With reference to the EDS sought by the RO, MOEFCC, GOI, Dated-13/08/2018, reply is furnished at your end but the reply is not satisfactory for some of the EDS, kindly rectify the same as per the mentioned action-

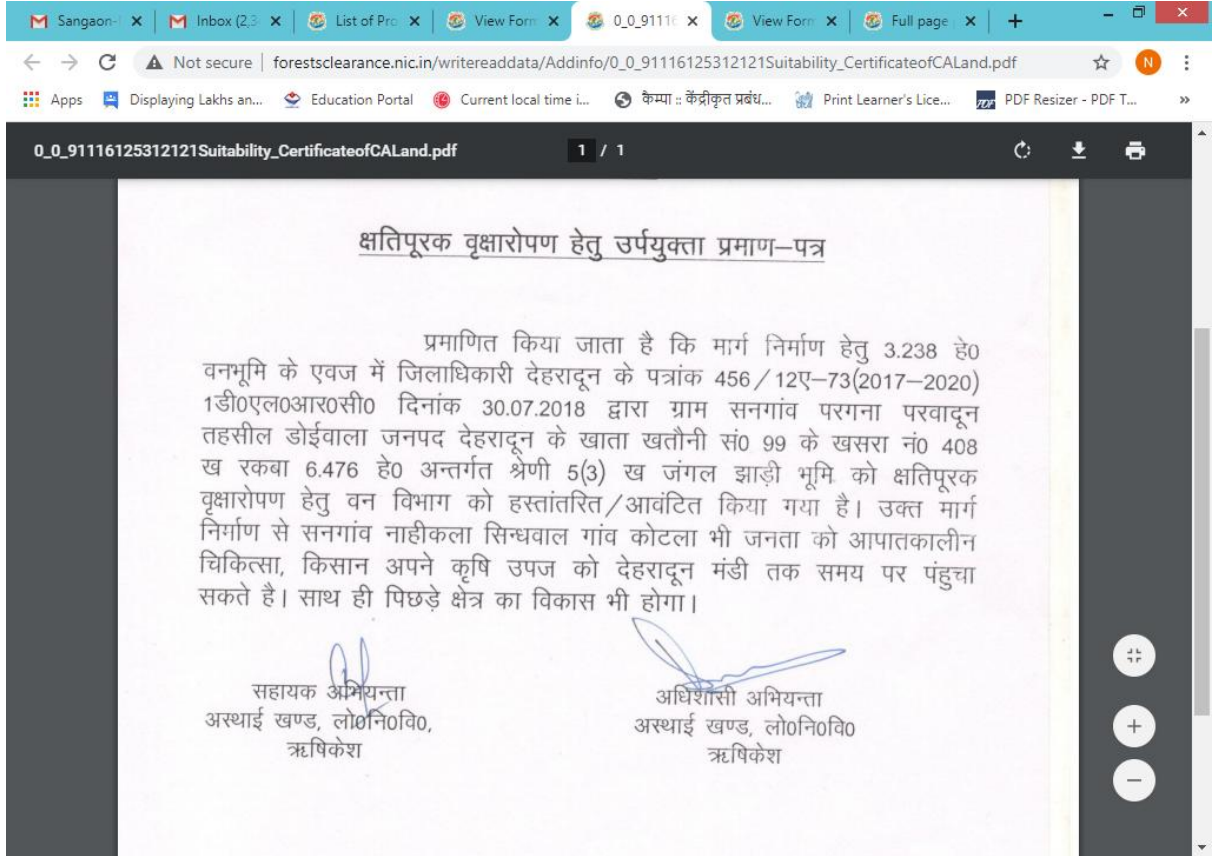
- 2- For point no. 2, As per muck disposal plan complete 96530 cum balanced muck is proposed to be disposed in NFL area but details of muck disposal area not filled at para B.4 in part I. State Government may fill the detail of area proposed for muck dumping in non- forest land at para B 2.4 . Further, 11 km long road is covering good altitude from the base so adequate care must be taken to check the soil erosion and stabilize the muck disposal sites.
Action to be taken- Detail of muck to be mentioned at B-2.4-component wise breakup, as the same has not been mentioned at the relevant place.(as per above screenshot).
- 3- For point no. 6, As per DSS analysis of CA area, 1 ha. area found in MDF proposed in civil soyam land. State Govt. may either submit the certificate of DFO certifying that the area is

suitable for CA purpose, along with the list of trees present in MDF area or may change this area with some other area which is suitable for CA.

Action to be taken- Please upload the site suitability certificate as the document uploaded is not correct as well as the same has not been signed by the DFO.(Screenshot is attached for your reference).

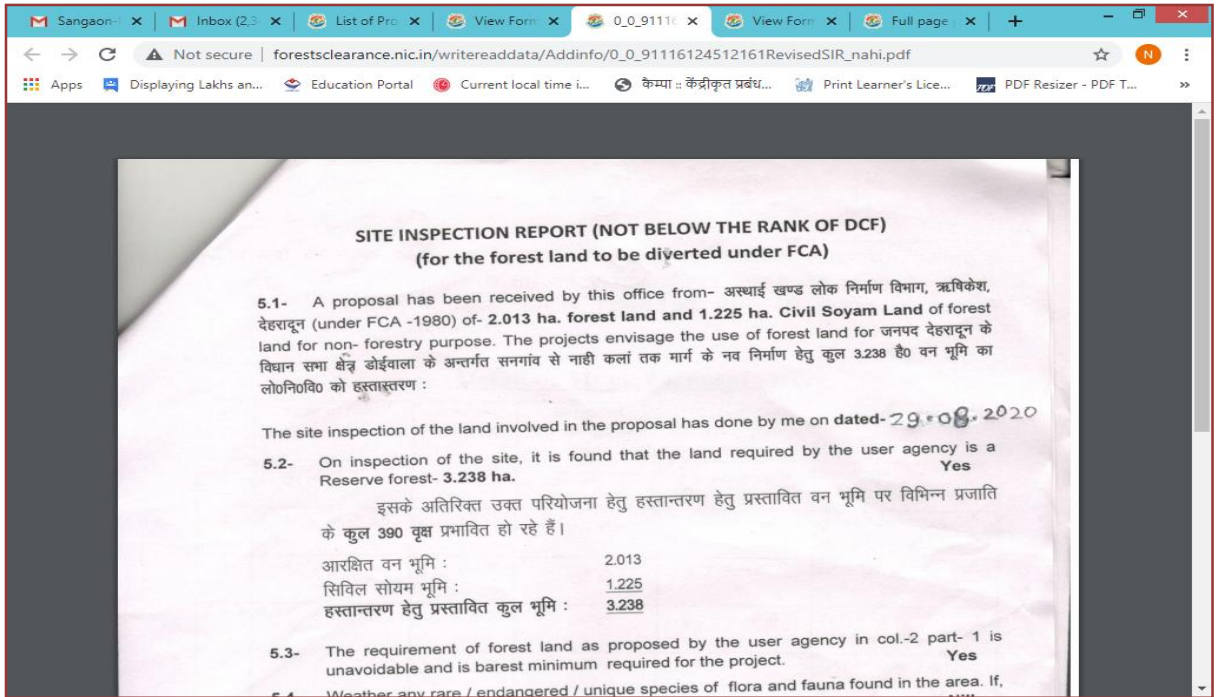
- 6- For point no. 11, Complete 3.238 ha area is mentioned as RF in DFO's SIR certificate 1.225 ha. area is mentioned as Civil soyam land. State Government may clarify.
Action to be taken- Still the area is mentioned as reserved area, Kindly rectify the same.(screenshot is attached for your reference).
